### DUKE POWER COMPANY

### OCONEE NUCLEAR STATION, UNIT 1

### AMENDMENT TO FACILITY OPERATING LICENSE

Amendment No. 184 License No. DPR-38

Oconee Nuclear Station Figure 3.5.2-16

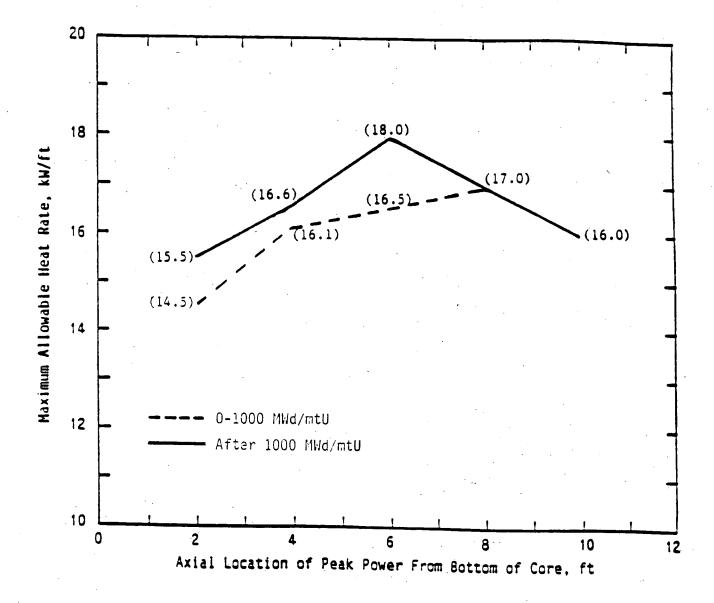
LOCA-Limited Maximum Allowable Linear Heat
